Economic Commission for Europe**Inland Transport Committee****World Forum for Harmonization of Vehicle Regulations****Working Party on Noise****Fifty-sixth session**

Regulation No. 41 (Noise of motorcycles)**Proposal for Supplement 1 to the 04 series of amendments to Regulation No. 41****Submitted by the expert from the Russian Federation***

Appendix 2, the figure, amend to read:

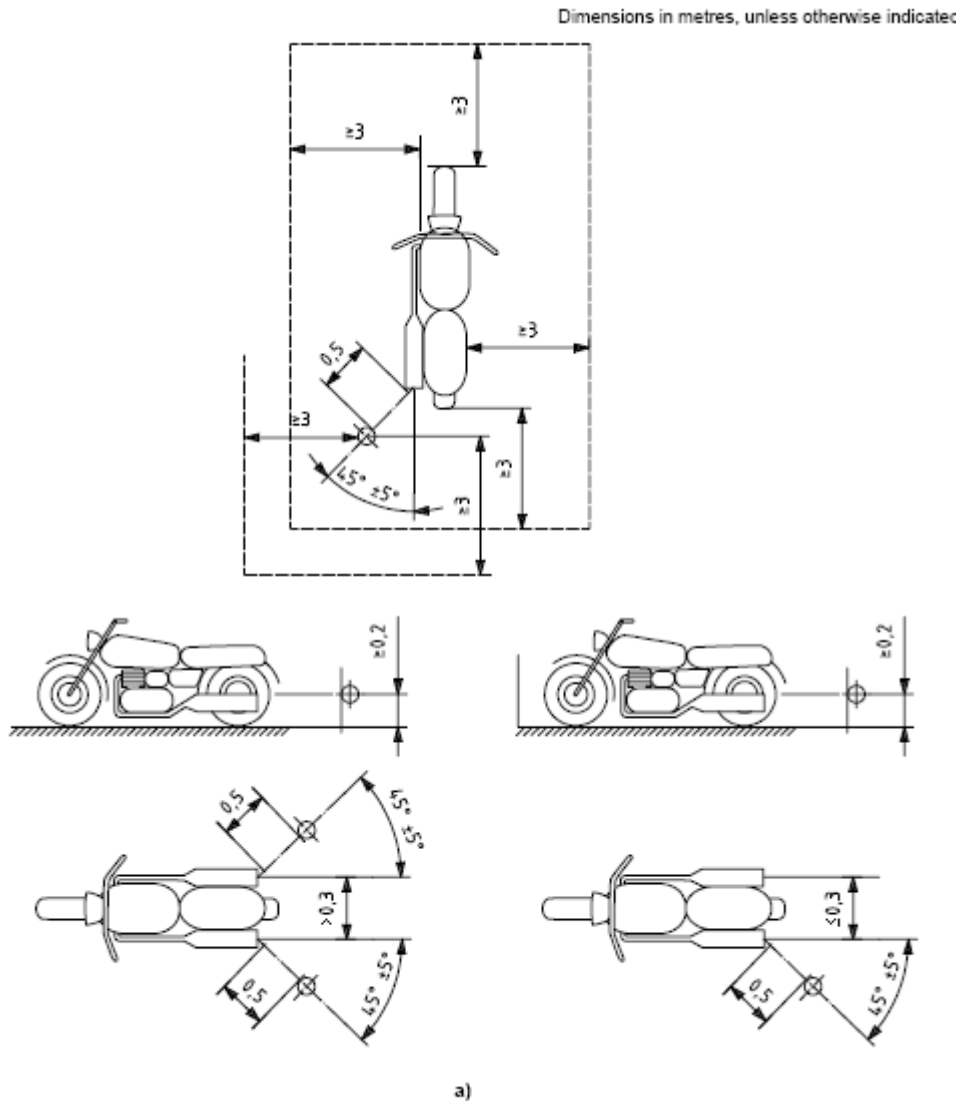
- "2.4.1. ... If a vehicle has two or more exhaust outlets spaced ~~less~~ **not more** than 0.3 m ..."

25. *Annex3, Appendix 2:* The mathematical sign " \geq " is related to a distance between silencers. Therefore it should be changed to " \leq ".
26. *Annex 5. Heading and paragraph 1.:* "Exhaust or silencing systems" is substituted by "exhaust or intake systems", which seems more correct.
